ADA IMPROVEMENTS – PHASE 1

**KILLINGLY MEMORIAL SCHOOL
339 MAIN STREET
DANIELSON, CT 06239
STATE PROJECT NO. 069-0068 CV**

DATE: October 18, 2018

The following changes to the Drawings and Project Specifications shall become a part of the Drawings and Project Specifications; superseding previously issued Drawings and Project Specifications to the extent modified by Addendum No. 2.

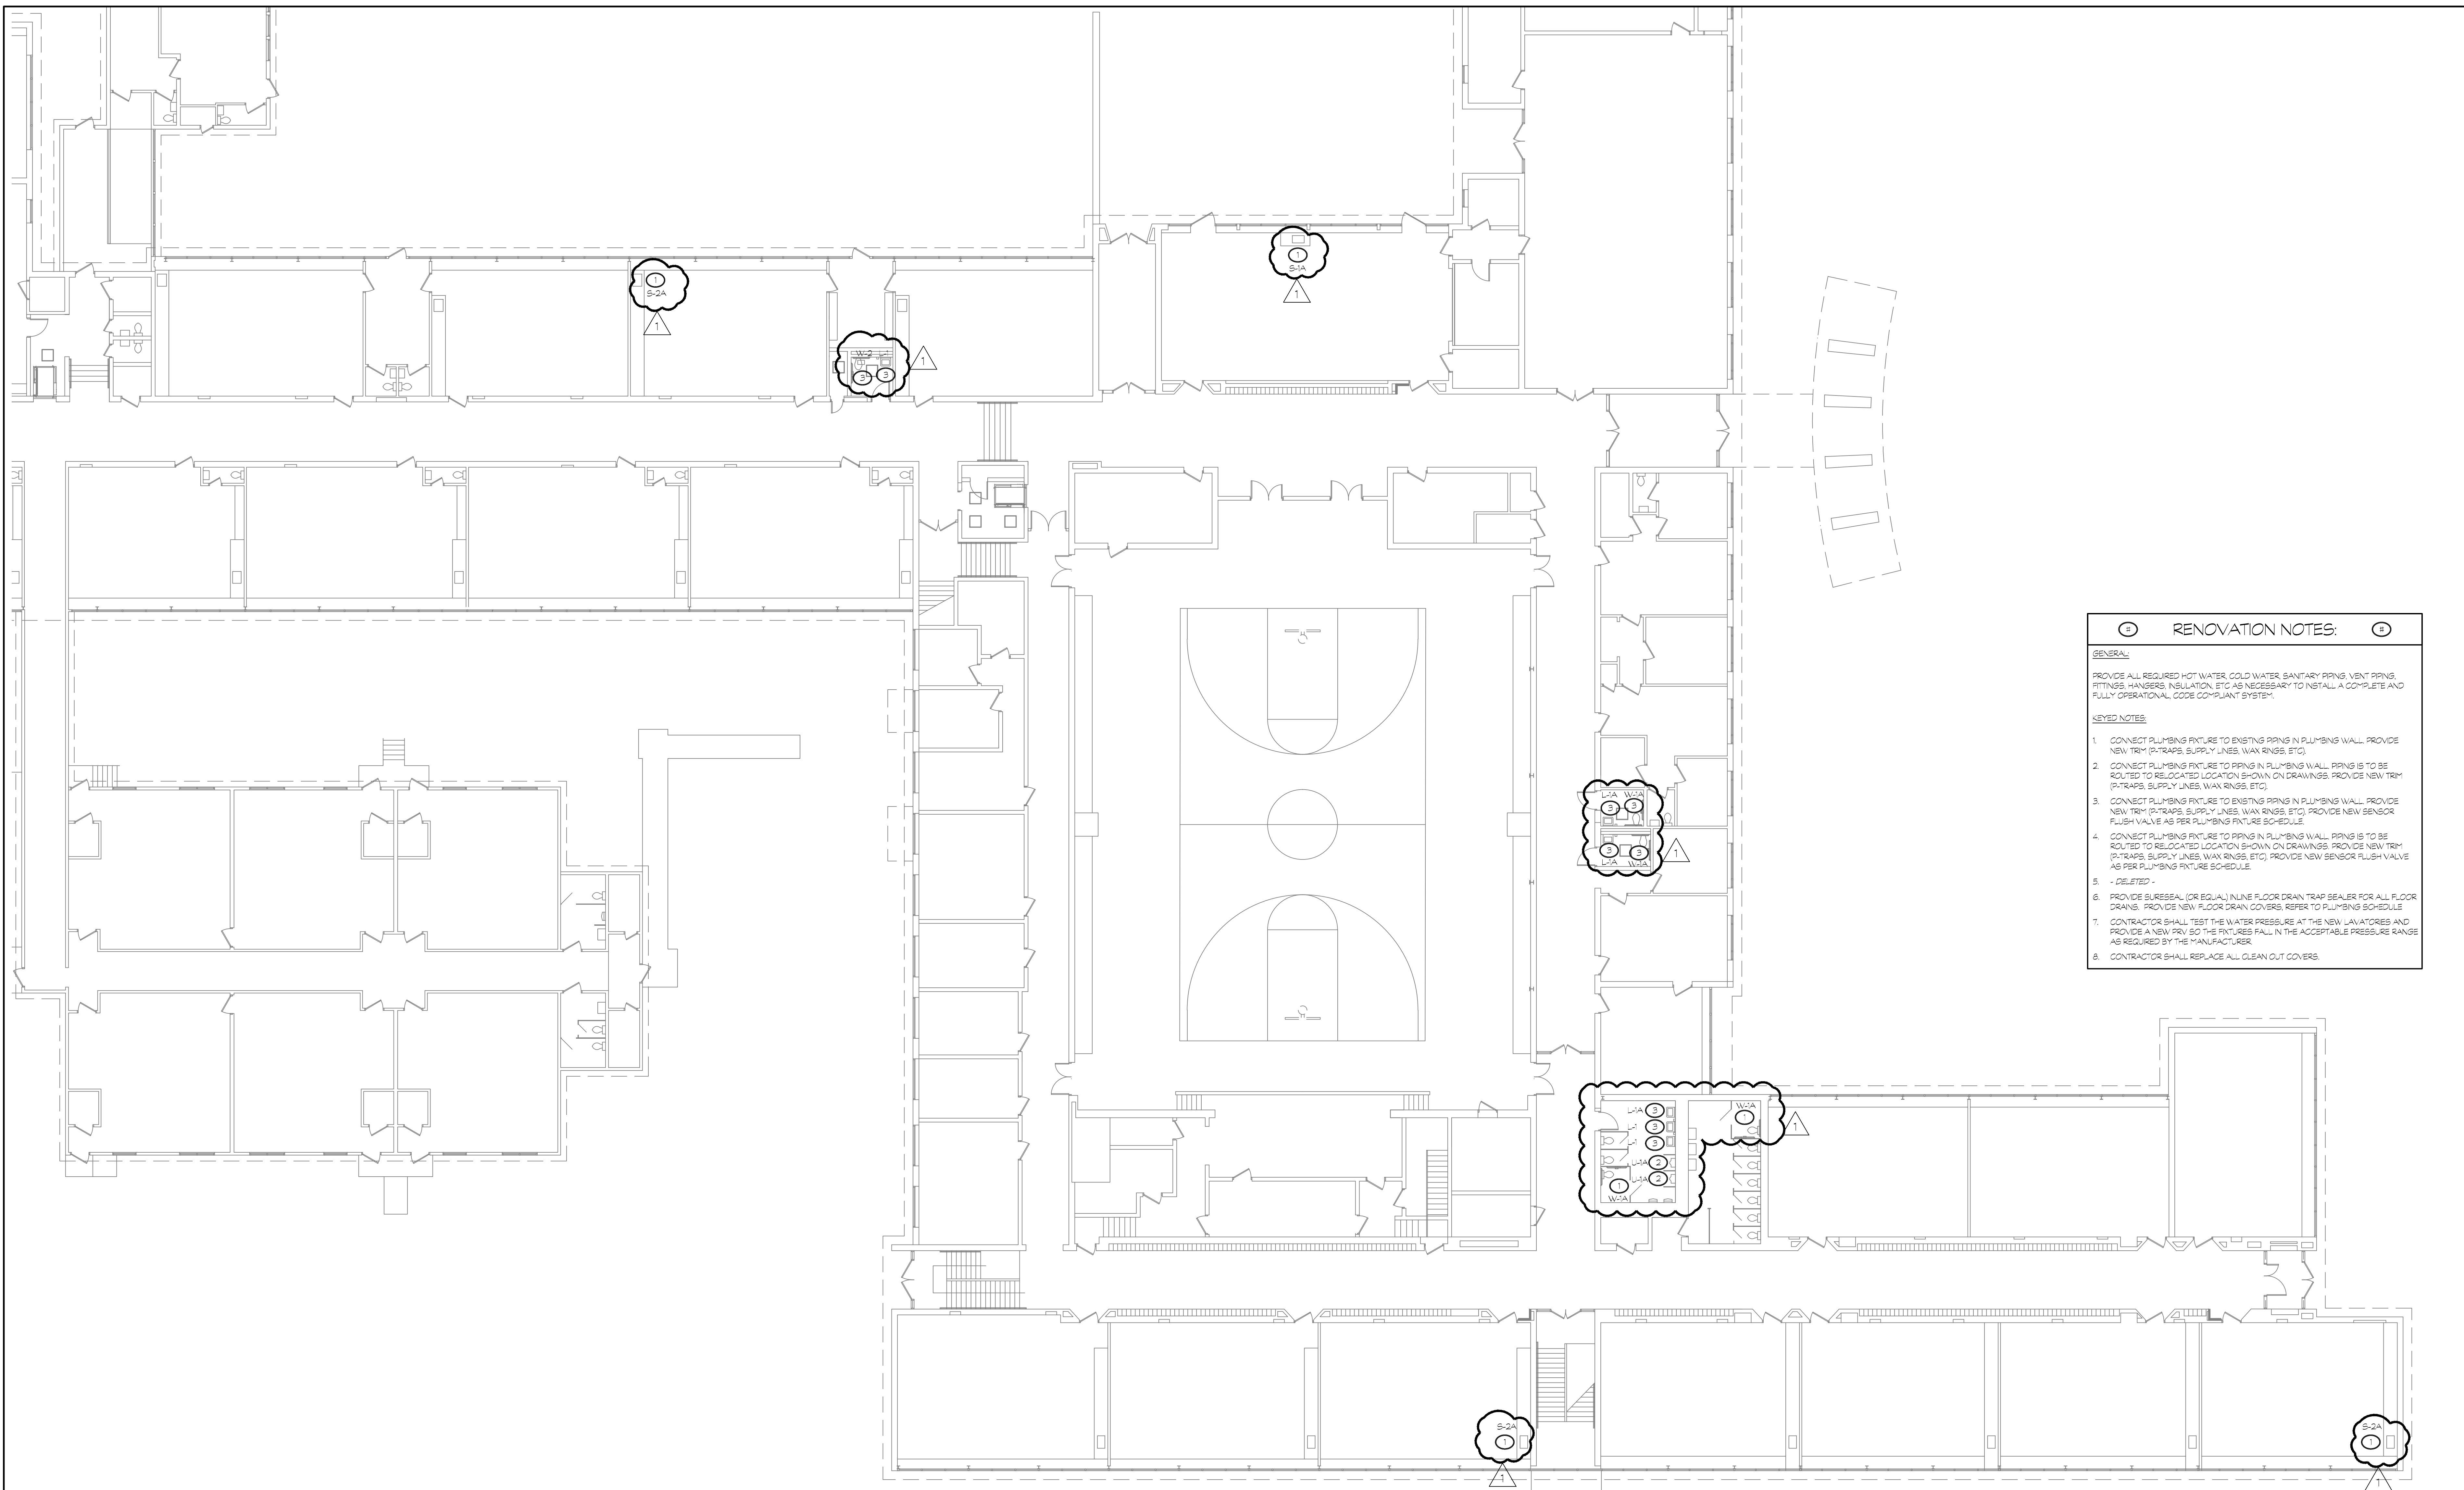
- DRAWING A121, ENLARGED PARTIAL PLANS:
 - Enlarged Plan – Community Room E58 1, Community Room E58, add Elevation Tag “5/A410” point towards the casework. *(Per RFI #001)*
 - Enlarged Plan – Classroom #14 E32 5, Classroom #14 E32, add Elevation Tags “3/A410” facing South and “4/A410” facing West. *(Per Internal Review)*
- DRAWING A123, ENLARGED PARTIAL PLANS, Enlarged Plan – Vestibule E27 & Classroom #18 E28, Classroom #18 E28, add Elevation Tags “3/A410” facing South and “4/A410” facing West. *(Per Internal Review)*
- The following PLUMBING drawings have been deleted in their entirety. New drawings have been added and are attached as part of this addendum*. (2) *(Per RFI #001)*
 - P101 MAIN LEVEL FLOOR PLAN PLUMBING
 - P901 PLUMBING SCHEDULES

1. If the contractor decided to perform work during the school year, will there be any associated cost for someone (custodian) to open/oversee/close the schools during off hours such as nights and/or weekends? **-There will be no associated cost.**
2. Both sets of drawings do not label the new fixtures on the plumbing drawings. There are multiple types of sinks and toilets therefore we do not know the quantities of each. The millwork drawings also call for a combination sink & drinking fountain which is not found in the fixture schedule. Are the sinks and drinking fountains in the millwork stainless steel or integral to the solid surface counter? Please advise. **-Plumbing drawings will be updated in forthcoming addendum. Sinks are to be stainless-steel.**
